# Product Change Notice

**Product : Samsung LH181B (SCP\*\*TF1HEL1\*\*\*\*\*)**

**Change : Manufacture site**

**2022.Dec.21**

# 0. How to distinguish

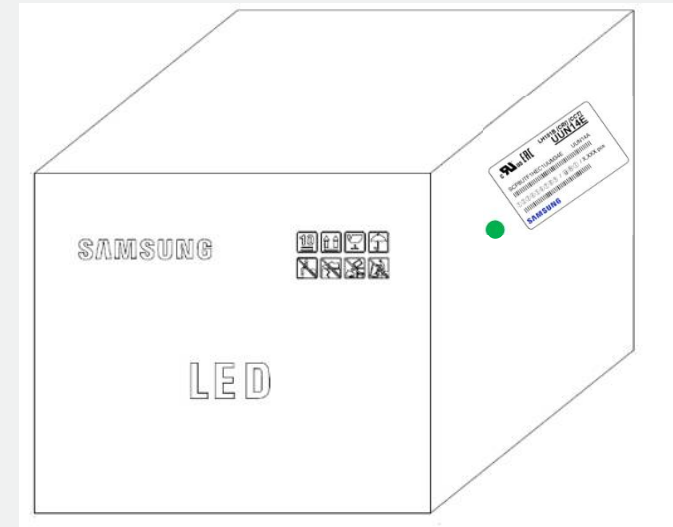
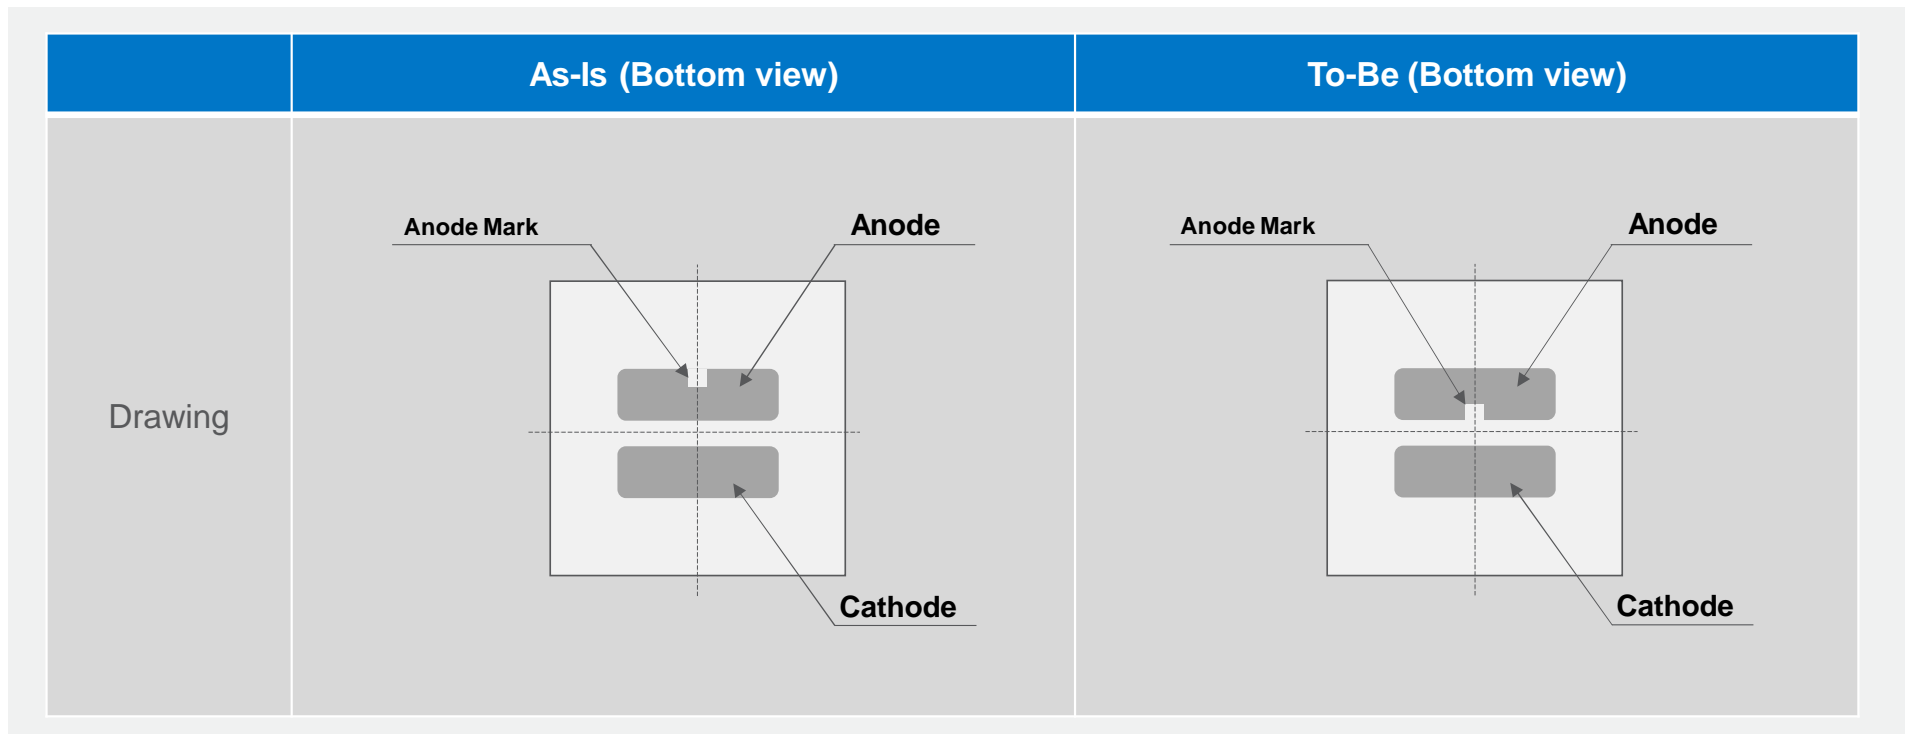
- China product apply green mark on reel, vinyl bag and box.

※ Recommendation : Do not use old mixed with new products when assembling modules.

## 2. Exterior and Performance

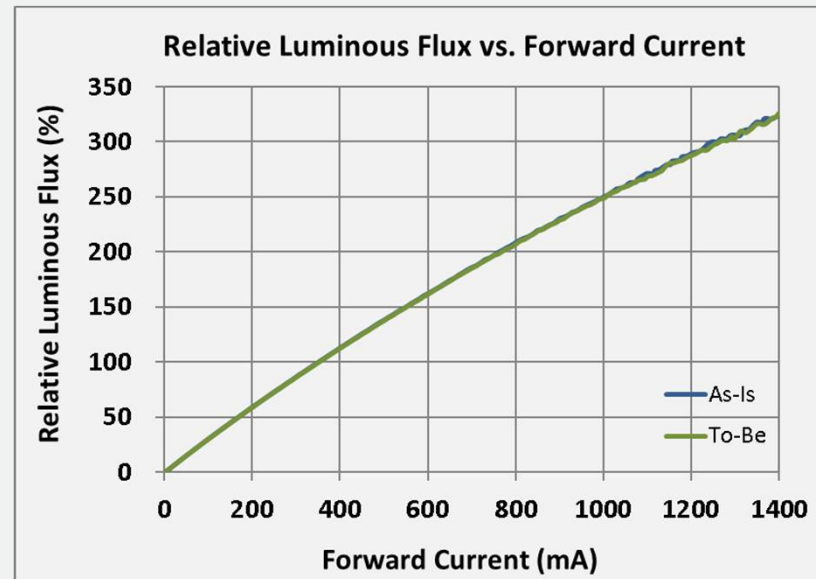
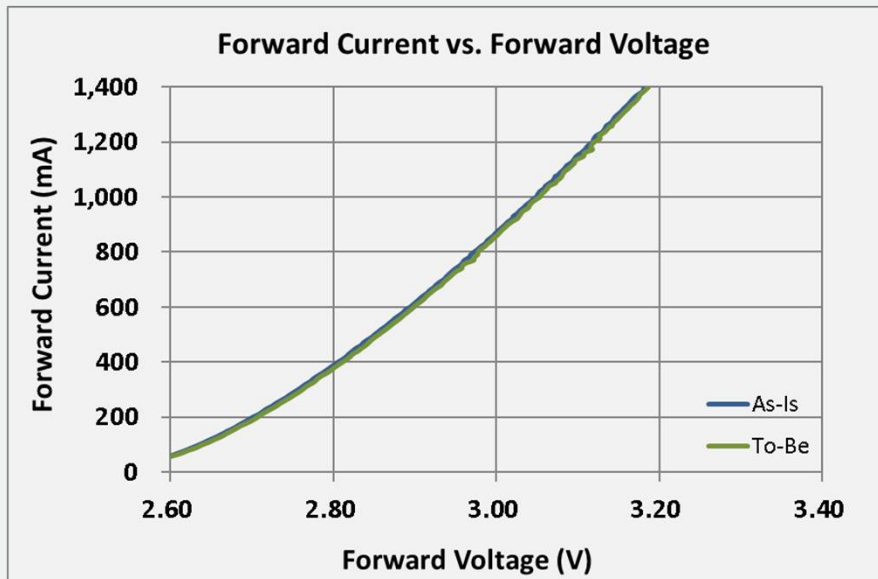
- Slight improvement

As-Is	To-Be
Exterior		
Output Lumen (lm)	179.5	181.4
Vf (V)	2.77	2.78
Efficiency (lm/W)	185.1	186.4
CRI	73.2	73.3

## 4. Comparison thermal sweep

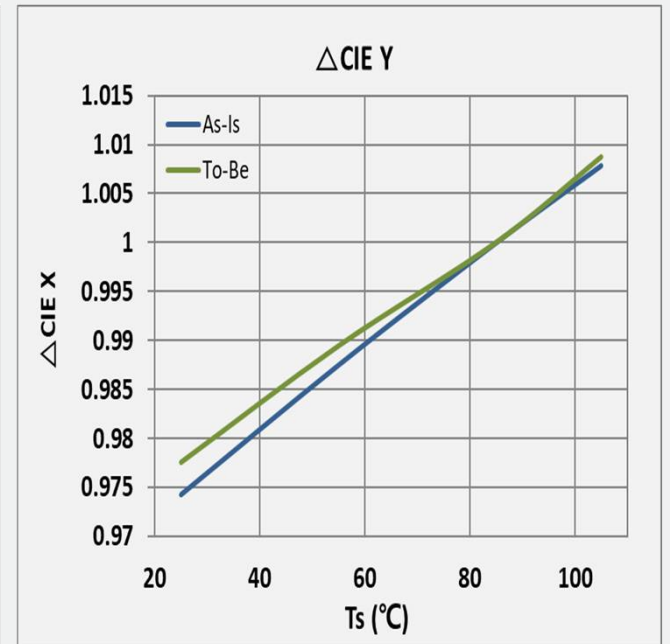
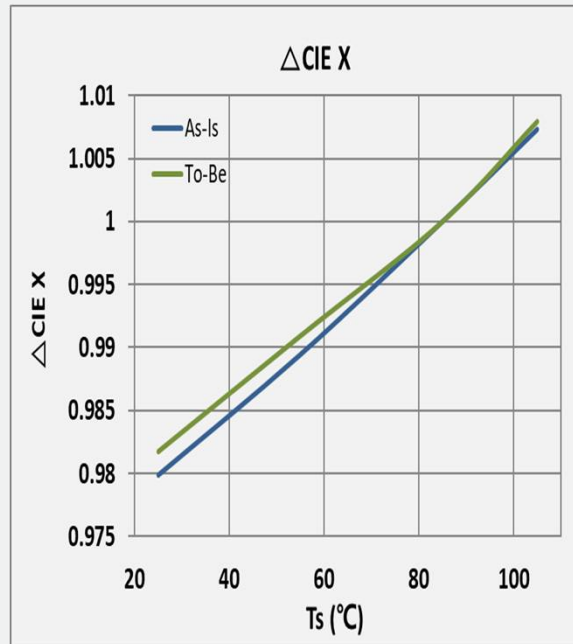
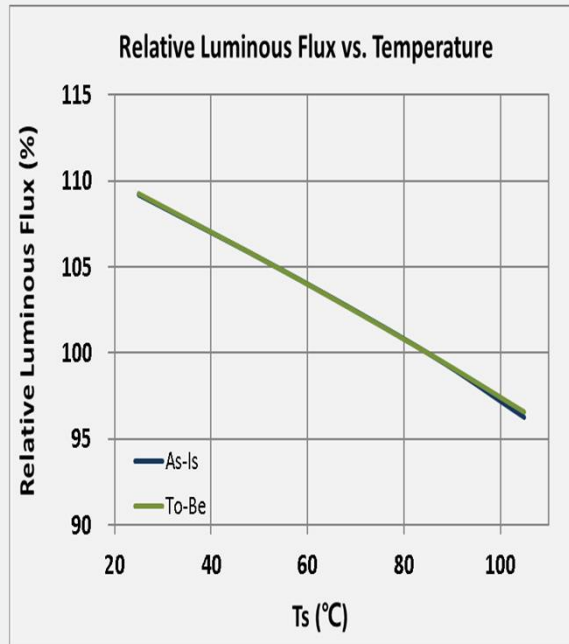
- Improvement

# 5. Comparison COA

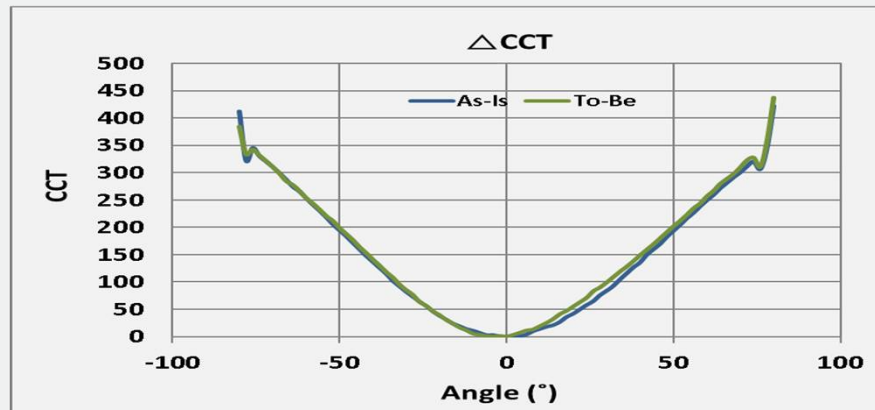
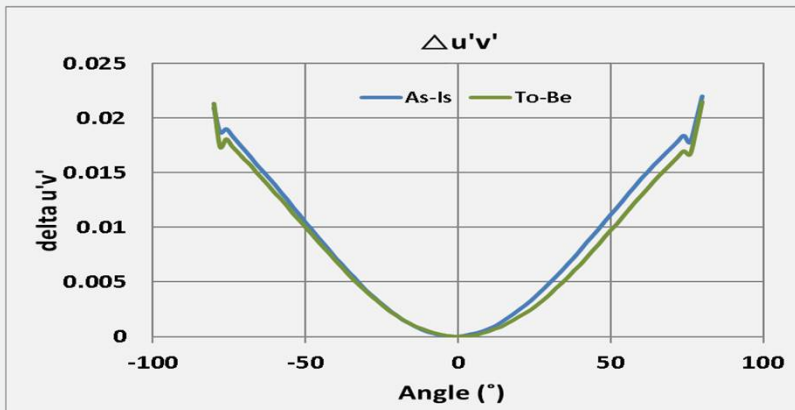
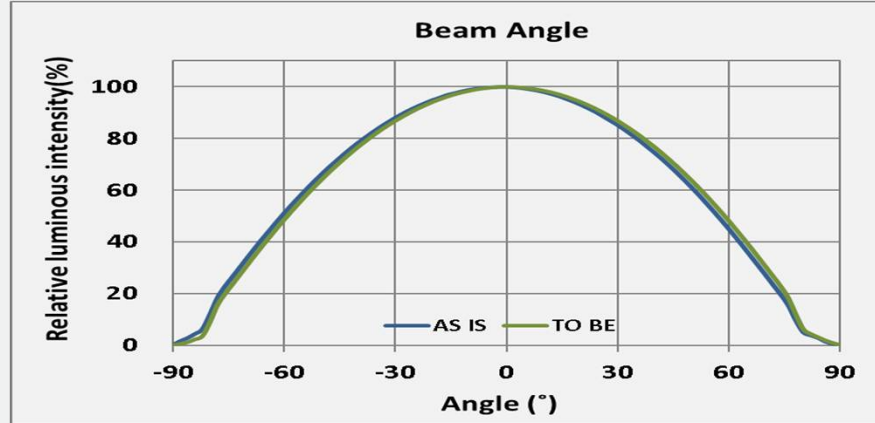
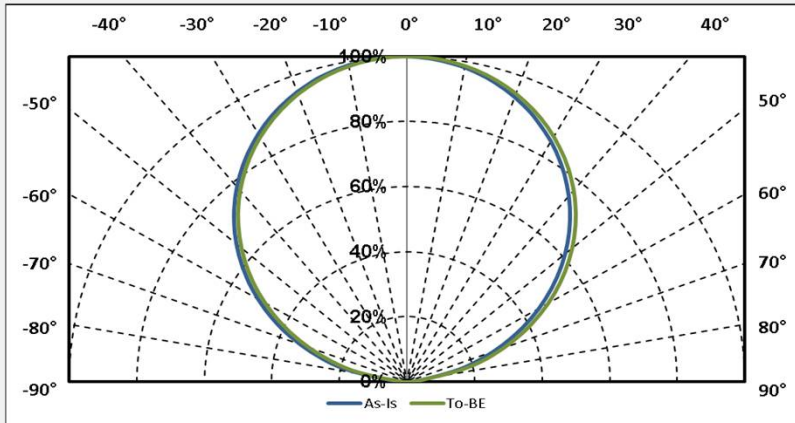
- Comparable

## 6. Reliability Test Results of new P/N

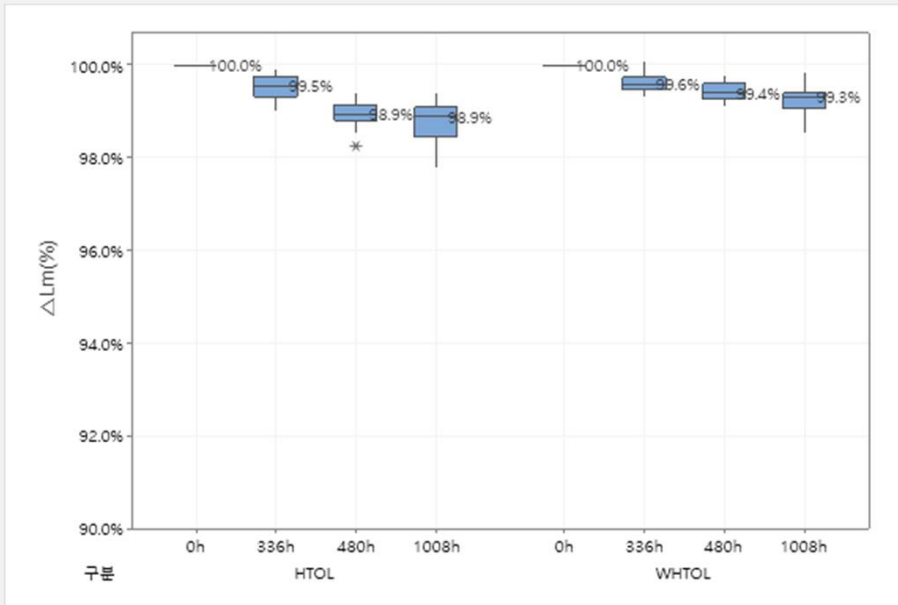
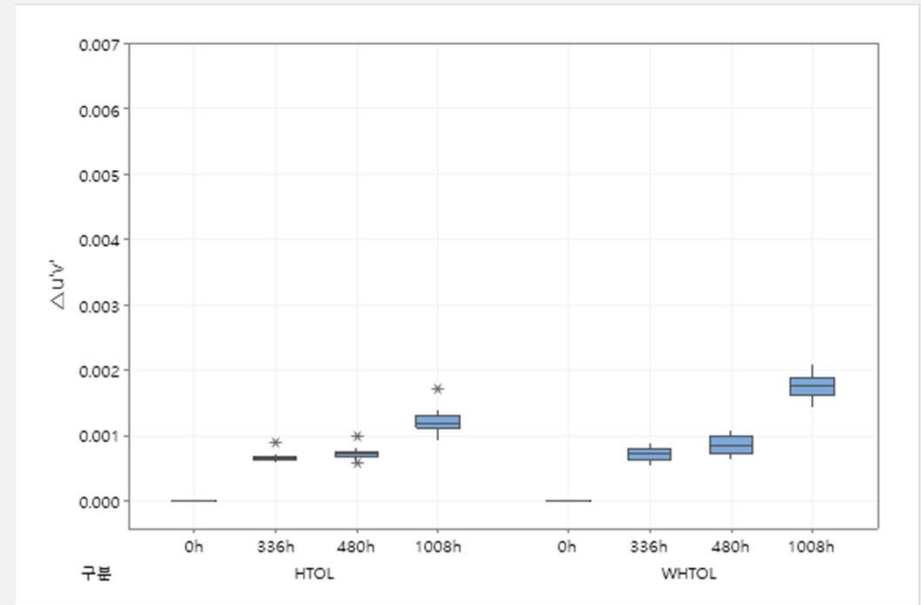
### Pass

Test	HTOL (85°C) (1008hr)			WHTOL (85°C/85%RH) (1008hr)			T/C (-45~125°C, Each 15min)
	$\Delta VF$	$\Delta I_m$	$\Delta u'v'$	$\Delta VF$	$\Delta I_m$	$\Delta u'v'$	
Result	100.0%	98.9%	0.0012	100.0%	99.3%	0.0017	700cyc Pass
